15E ATWS Performance Evaluation

The information in this appendix of the reference ABWR DCD, including all subsections, tables, and figures, is incorporated by reference with the following departures.

Figure 15E-1a ATWS Mitigation Logic (ARI, FMCRD Run-In, RPT, Manual Initiation)

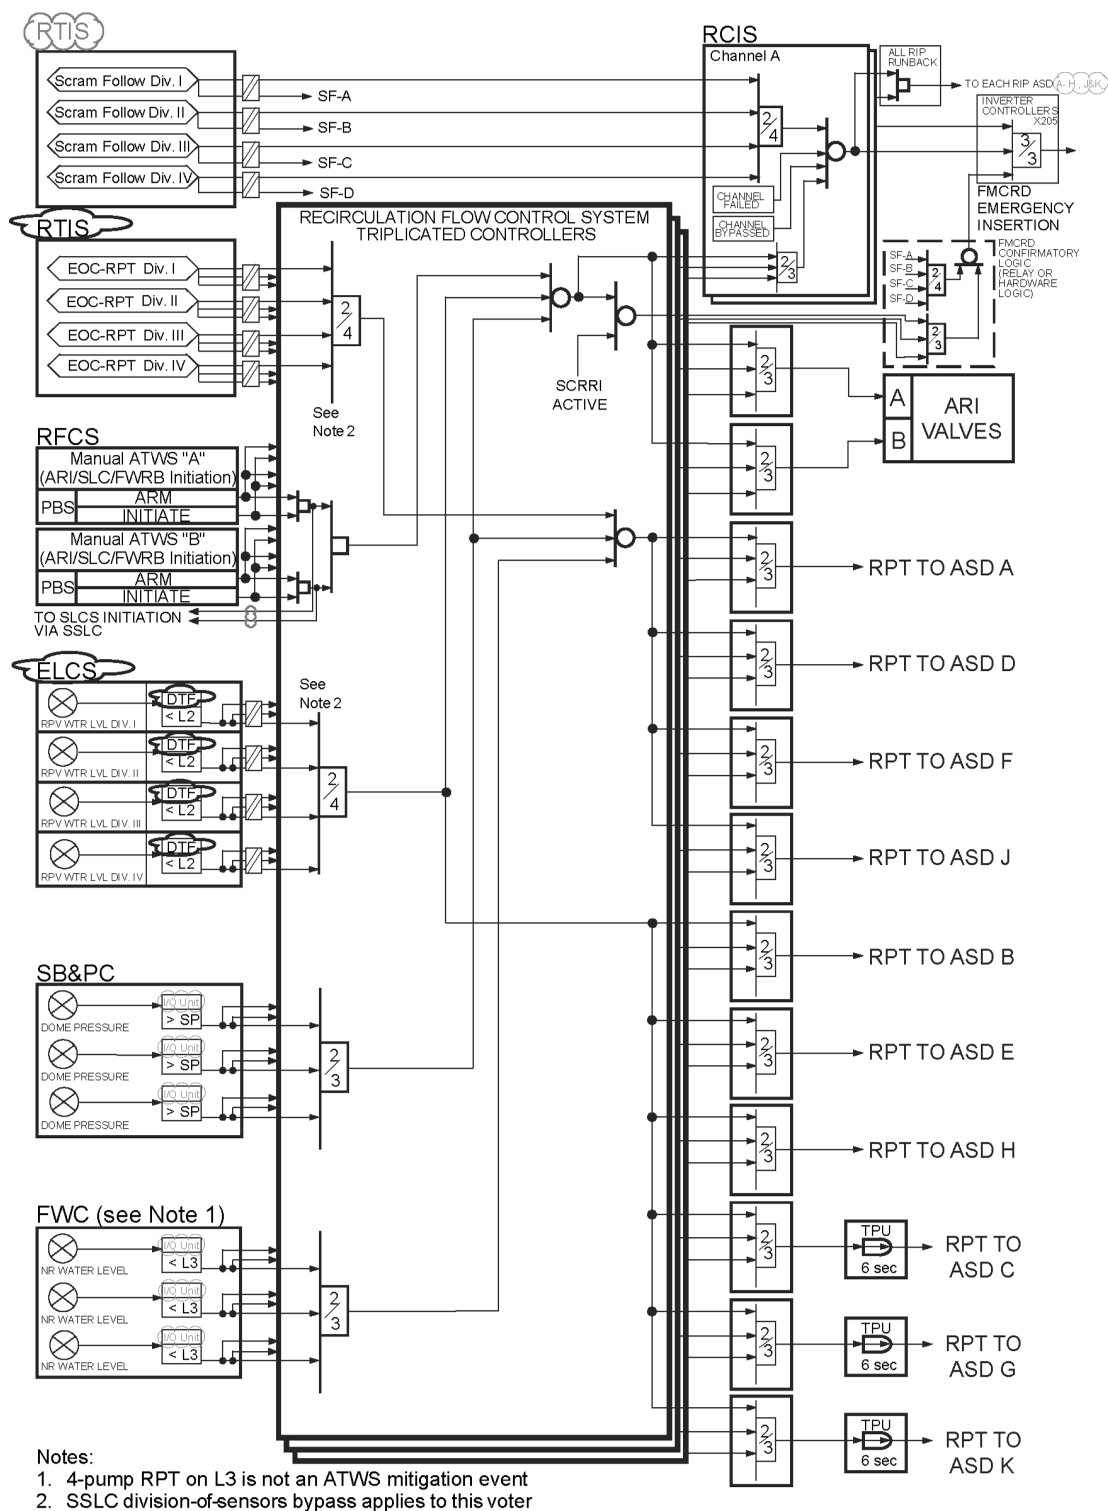
STD DEP T1 3.4-1 (Figures 15E-1a, 15E-1b, 15E-1c)

STD DEP Admin ([Figure 15E-1a](#), [Figure 15E-1b](#))

Figure 15E-1b ATWS Mitigation Logic (SLCS Initiation, Feedwater Runback)

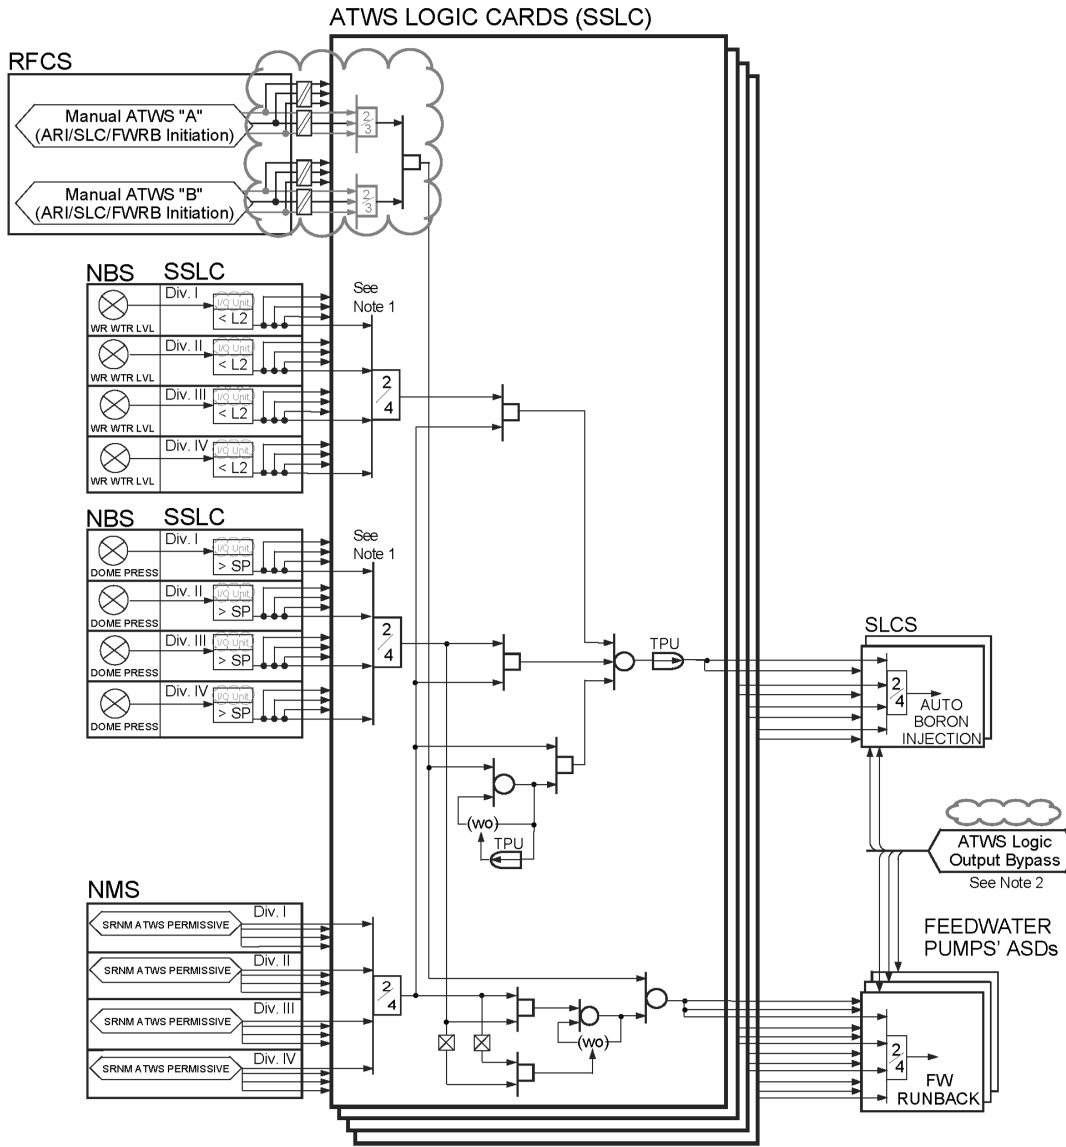
[STD DEP 16.3-83 \(Figure 15E-1b\)](#)

NOTES:
 1. ~~ELCS~~ DIVISION-OF-SENSORS BYPASS APPLIES TO THIS VOTER
